Staff Summary Report

SUBJECT: Hold a public meeting for a Development Plan Review for FIRST BAPTIST CHURCH, located at 4525 S. McClintock Drive.

COMMENTS: Request for **FIRST BAPTIST CHURCH (PL080376)** (Dr. Roger Ball, Senior Pastor of First Baptist Church of Tempe, property owner; Denise Andreas, AIA, Todd & Associates, applicant) consisting of a new two-story 25,000 s.f. educational facility added to the existing church complex to create a total building area of 73,110 s.f. on 5.2 net acres, located at 4525 S. McClintock Drive in the R1-6 Single Family Residence District. The request includes the following:

DPR09001 – Development Plan Review including site plan, building elevations, and landscape.

CONCEPTUAL OVERALL 1ST FLOOR PLAN

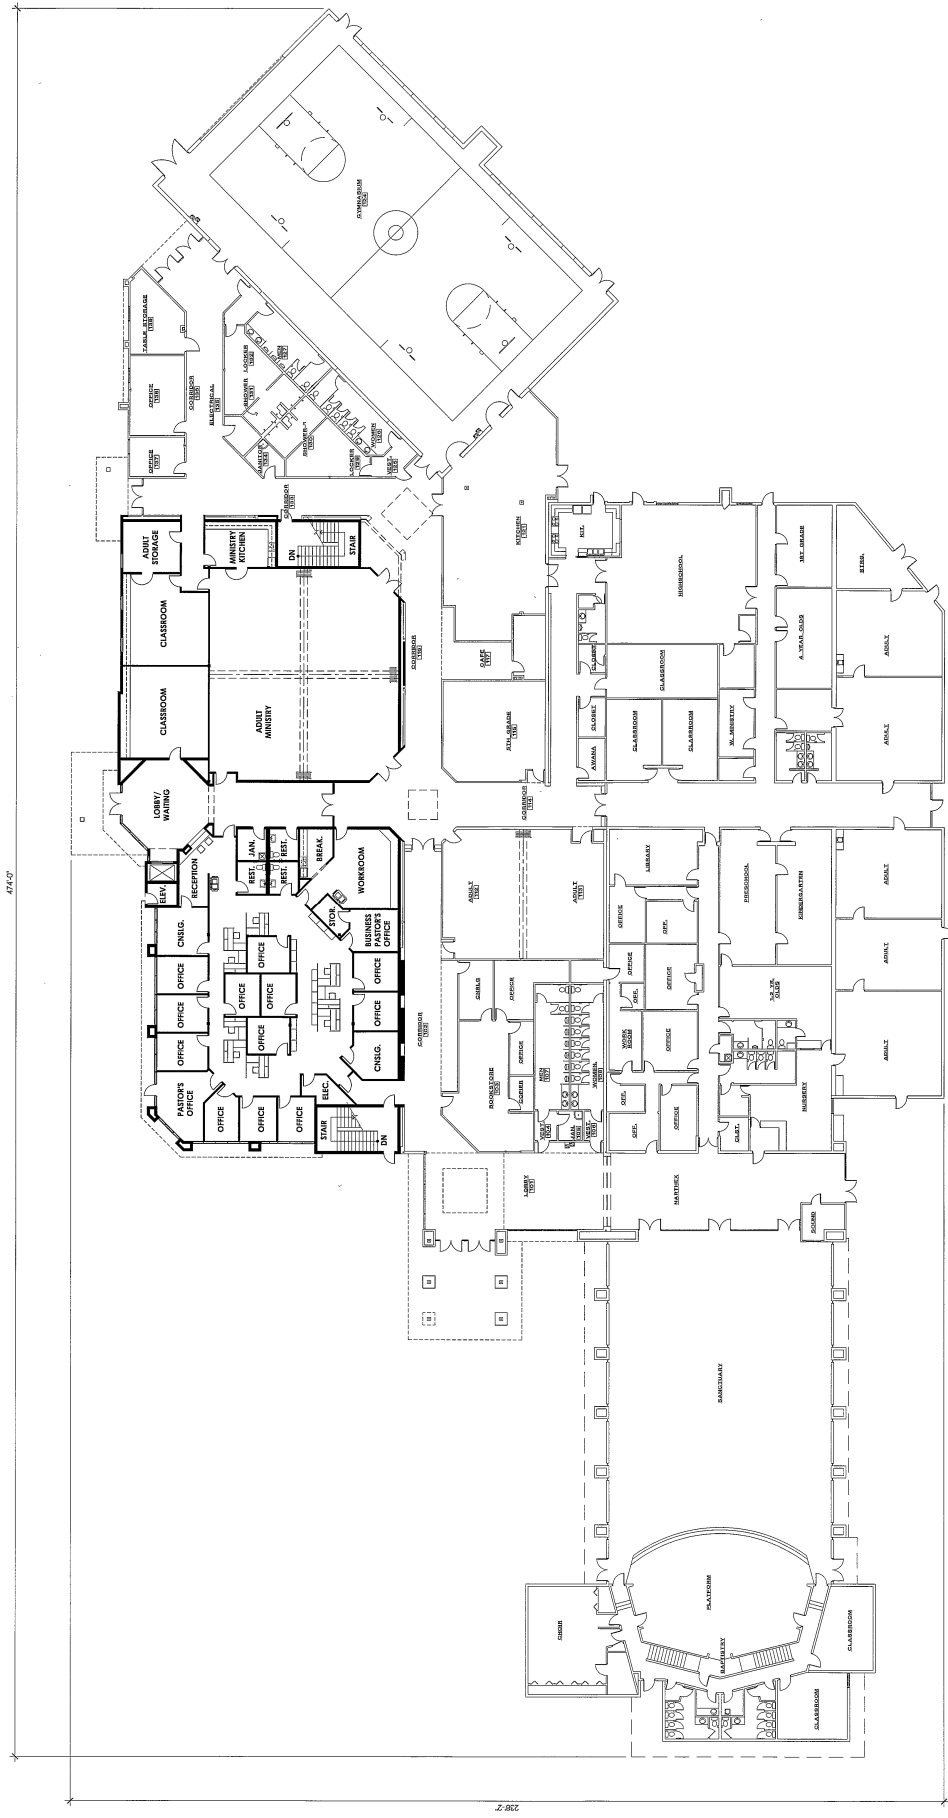
8. Exit Security:
 - a. Provide visual surveillance by means of fire-rated glazing assemblies from stair towers into adjacent circulation spaces.
 - b. In instances where an elevator or stair exit is within 21'-0" of an alcove, corner or other potential hiding place, position a refracting mirror to allow someone in the exit doorway to observe in the mirror the area around the corner or within the alcove that is adjacent to the doorway.

PRELIMINARY LANDSCAPE PLAN

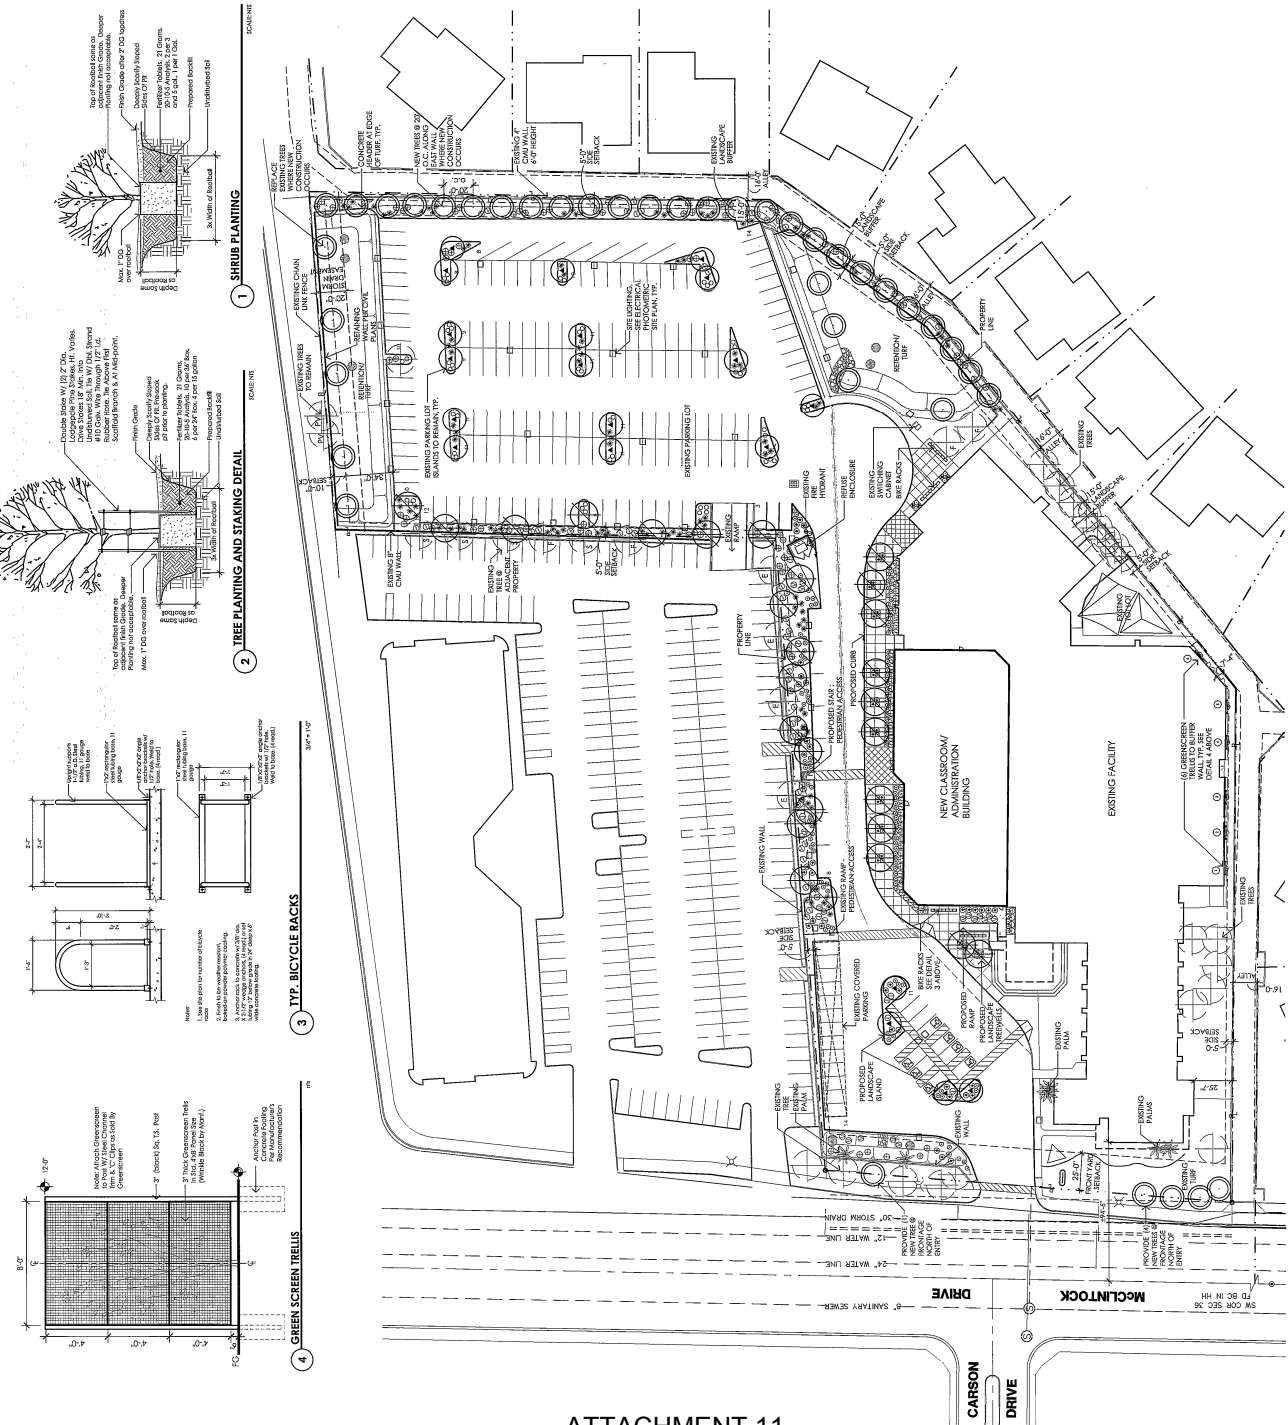
The proposed landscape plan improves the existing conditions. Trees along the eastern perimeter of the site are currently a deciduous variety that provides little visual screening during the winter months. The applicant is proposing to provide new Sissoo trees every 20 feet on center along the eastern perimeter. Existing trees along the southern perimeter, as well as along the northern and western perimeter, are proposed to be retained, with the addition of trees as needed to meet code requirements. Proposed tree species within the parking lot would be Evergreen Elm, proposed species along the north-west borders are Cathedral Oak, and street tree additions would be Sissoo. All proposed new species are evergreen variety. The shrubs are a combination of flowering plants, accents are red yucca and deer grass, and ground covers and vines provide additional color accents. Turf is limited to existing locations. Green screens have been added with Brazilian Skyflower Vine to soften the southern façade of the existing building.

14. The plant palette is approved as proposed and specified on the landscape plan, including replacement of non-evergreen (deciduous species) with evergreen species along the east and south perimeter of the property. Any additions or modifications may be submitted for review during building plan check process.
